Contract #: 04-0120F4Cty: SF/ALA Rte: 80 PM: 13.2/13.9File #: 69.25B**QUALITY ASSURANCE -- NON-CONFORMANCE REPORT****Location:** Changxing Island, Shanghai, P.R. China**Report No:** NCR-000492**Prime Contractor:** American Bridge/Fluor Enterprises, a JV**Date:** 17-Oct-2009**Submitting Contractor:** Zhenhua Port Machinery Company, Ltd (ZPMC), Changxing Island**NCR #:** ZPMC-0465**Type of problem:**

Reference Description: Blasting and Painting of OBG Segment 6CE prior to obtaining the "QA Approval Form"

Subject: NCR No. ZPMC-0465

REGARDING: NCR-000492(ZPMC-0465)

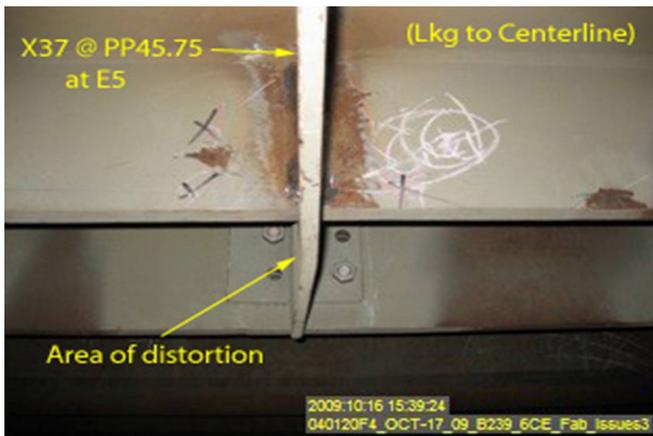
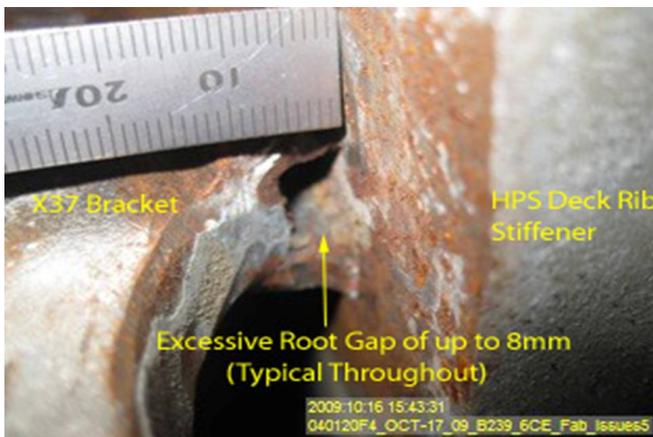
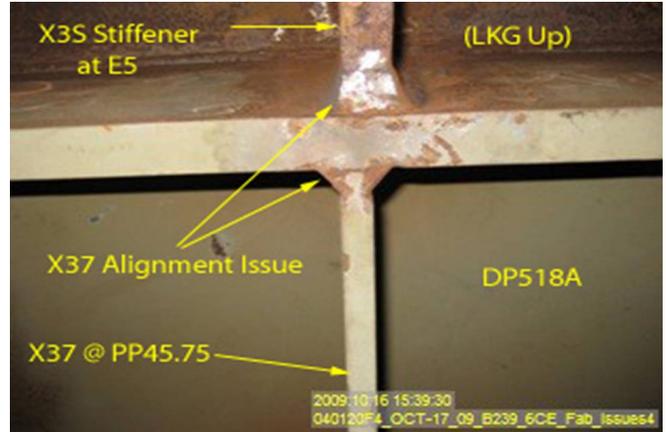
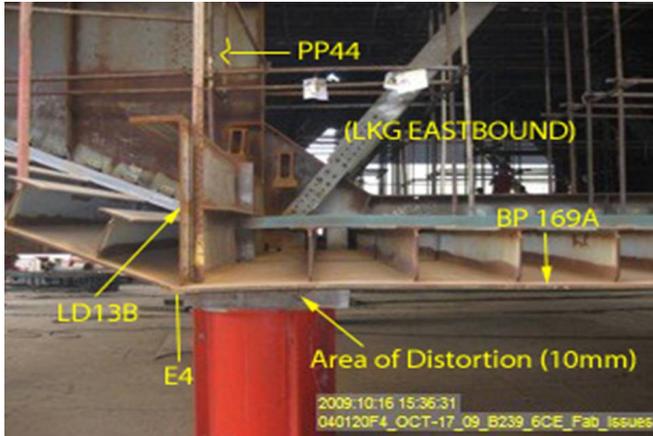
The Caltrans Quality Assurance (QA) Inspector arrived onsite at the ZPMC fabrication facility at 0700 on October 17th, 2009 and observed that the OBG segment 6CE had been moved to the shop for blasting and painting the previous night prior to the completion of the following fabrication and obtaining the "QA Approval Form" per CCO77.

1. Bottom Panel BP169A and the transverse angle X74E were found with distortion measured up to 10mm at the storage block location for panel point 43.5 at work point E4.
2. The transverse X37 Deck Brackets in this segment require a fillet weld per approved drawings with the maximum root opening not to exceed 5mm as allowed by AWS D1.5/2002 Section 3.3.1. The termination of these fillet welds at the following locations show a root gap greater than that allowed by the code:
 - X37 Brackets at Location E2 at the following panel points: 43.25, 43.75, 44.25, 44.75, 45.25, 45.75, 46.25, and 46.75.
 - X37 Brackets at Location E5 at the following panel points: 45.25, 45.75, 46.25, and 46.75.
3. The transverse X37 Deck Bracket at panel point 45.75 at location E5 is distorted and misaligned with the adjacent X3S Deck Stiffener.

Part 1. The Bottom Plate BP169A is assisting with the bottom transverse splice weld. The bottom splice weld has been finished and is now acceptable.

Part 2. All the X37s where the root opening exceed 5mm have been removed from CA and the free edges were built up to ensure the root opening to be satisfied.

Part 3. ZPMC has adjusted the misalignment of X3S at PP45.75.

Reference Description: Blasting and Painting of OBG Segment 6CE prior to obtaining the "QA Approval Form"

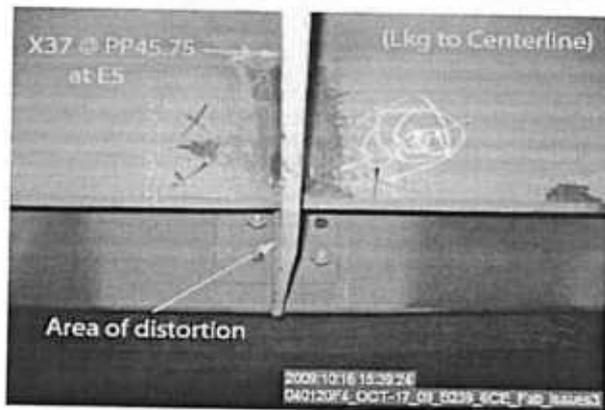
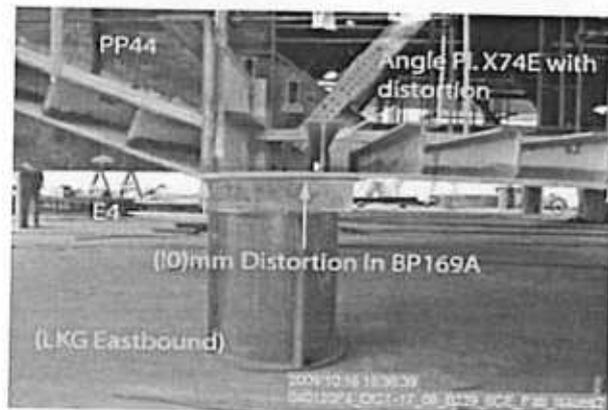
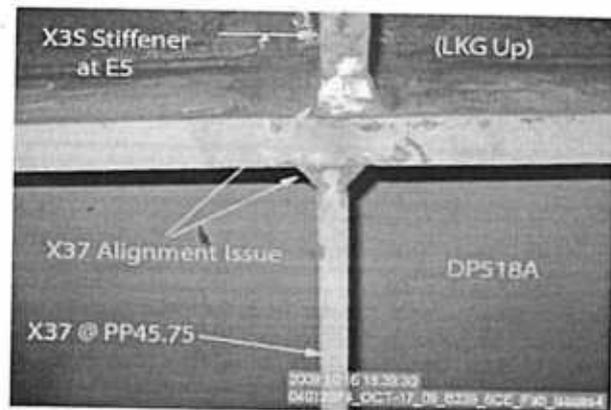
The Caltrans Quality Assurance (QA) Inspector arrived onsite at the ZPMC fabrication facility at 0700 on October 17th, 2009 and observed that the OBG segment 6CE had been moved to the shop for blasting and painting the previous night prior to the completion of the following fabrication and obtaining the "QA Approval Form" per CCO77.

1. Bottom Panel BP169A and the transverse angle X74E were found with distortion measured up to 10mm at the storage block location for panel point 43.5 at work point E4.
2. The transverse X37 Deck Brackets in this segment require a fillet weld per approved drawings with the maximum root opening not to exceed 5mm as allowed by AWS D1.5/2002 Section 3.3.1. The termination of these fillet welds at the following locations show a root gap greater than that allowed by the code:
 - X37 Brackets at Location E2 at the following panel points: 43.25, 43.75, 44.25, 44.75, 45.25, 45.75, 46.25, and 46.75.
 - X37 Brackets at Location E5 at the following panel points: 45.25, 45.75, 46.25, and 46.75.
3. The transverse X37 Deck Bracket at panel point 45.75 at location E5 is distorted and misaligned with the adjacent X3S Deck Stiffener.

项目名称 Project Name	美国梅湾大桥 SFOBB	部件图号 Drawing No	X37A	报告编号 Report No.	B-WR8987
合同号 Contract No.:	04-0120F4	部件名称 Items Name	角单元加强筋板 Corner assembly stiffener	NDT报告编号 Report No. of NDT	NA
项目编号 Project No.:	ZP06-787

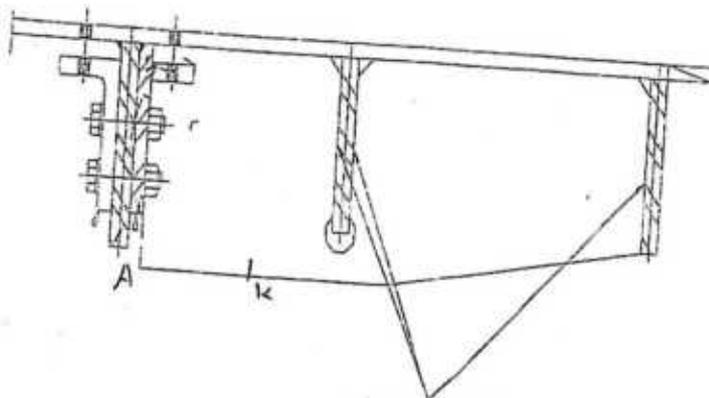
由于X37A与顶板I肋螺栓连接处的贴合面存在较大间隙，需去除部分焊缝，调整间隙，共15处。
The gap was exceeded requirement at X37A and deck plate I-rib bolt connect, and need to remove weld to adjusted gap, total 15 positions.

1. Remove the welds mentioned above by the way of cutting or gouging. Preheat according to the WPS prior to gouging.
2. Adjust item X37K after removing welds, if gap between I-Rib and item X37K exceed allowance, weld the item X37K before reassembling it.
3. Grind the edge of the repair area cleanly;
4. Prepare an right joint according to the approved WPS;
5. Perform 100%VT and 100%MT to the repair area to make sure no defects exist;
6. Preheat and weld according to the relevant WPS;
7. Grind the welds to flush with the adjacent base metal;
8. Perform relevant NDT inspection to the repair welds according to the working drawings.

项目名称 Project Name	英国海湾大桥 SFOBB	部件图号 Drawing No	X37A	报告编号 Report No.	B-WR9067
合同号 Contract No.:	04-0120F4	部件名称 Items Name	角单元加强筋板 Corner assembly stiffener	NDT报告编号 Report No. of NDT	NA
项目编号 Project No.:	ZP06-787

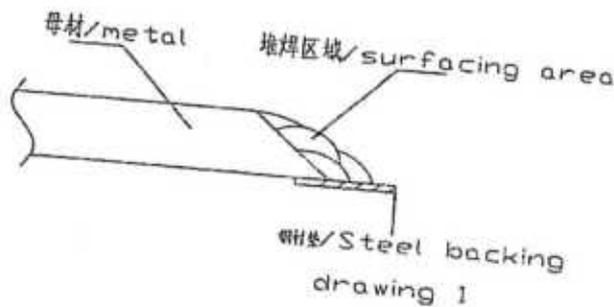
The gap exceeded requirement at east line six lifting corner assembly X37K and deck plate I rib after remove weld according to B-WR8987, it needed to build up X37A, total 15 parts.

1. Perform surfing to item X37A per work drawing;
2. Grind the edge of the repair area cleanly;
3. Prepare an right joint according to the approved WPS;
4. Perform 100%VT and 100%MT, and add steel backing according to the attached drawing 1 and AWS D1.5.3.13;
5. Preheat and weld according to the relevant WPS;
6. Gouge off the steel backing and grind the weld flush with base metal after welding;
7. Perform NDT inspection(VT、MT and UT) of the weld according to the working drawings.

项目名称 Project Name	美国海油股份 SFOBB	零件图号 Drawing No	DP518	报告编号 Report No.	3-WR10002
合同号 Contract No.:	04-0120F4	部件名称 Items Name	X37筋板	NDT报告编号 Report No. of NDT	NA
项目编号 Project No.:	ZP06-787

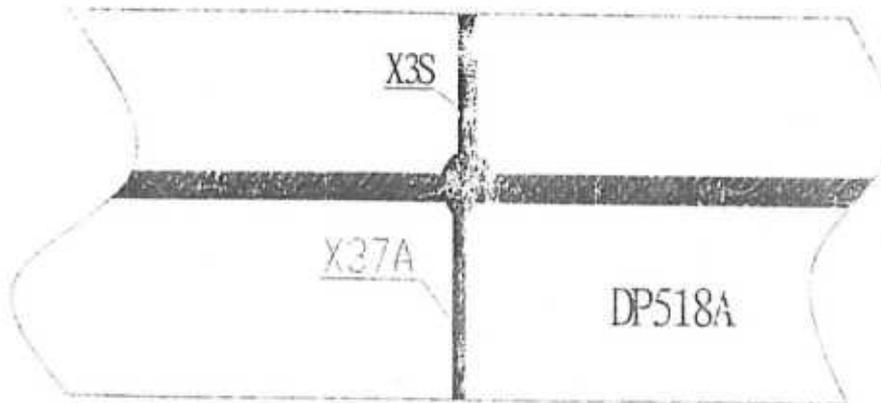
6CE顶板DP518A上安装的X37A筋板与X3S筋板对筋偏差 8 mm, 需要进行调整, 具体位置见下图:
Stiffener X37A and X3S on DP518A in segment DP518A were misaligned by 8mm, which need be adjusted. Please see the following sketch.

1. 采用碳刨的方法 equal 件 X3S 与 顶板、腹板的焊缝, 焊缝长度根据实际情况而定。注意不要伤及母材, 碳刨前应根据相应的 WPS 进行预热;
 2. 根据批准的返修 WPS 准备正确的焊接坡口;
 3. 按图纸要求调整件 X3S 位置使其与件 X8E 满足错边要求, 达 $\leq 3A$ 要求后定位;
 4. 焊接前对修补区域进行 VT 检测确认无缺陷存在;
 5. 根据批准的焊接工艺规程 (WPS) 进行预热及焊接;
 6. 焊接后将修补区域打磨光滑;
 7. 根据图纸要求对缝进行 NDT 检测;
1. Remove the welds between item X3S and DP and EP with a certain length by means of gouging, the length is determined by site situation. Be careful don't hurt base metal. Preheat according to relevant WPS prior to gouging;
 2. Prepare a proper weld groove according to approved repair WPS;
 3. Adjust item X3S to make its misalignment with item X8E meets requirement and then perform tack weld;
 4. Perform VT to the repair area to ensure no defect exist before welding;
 5. Preheat and weld according to the approved WPS;
 6. Grind the repair area to smooth finish.
 7. Perform relevant NDT to the weld in accordance with work drawing;
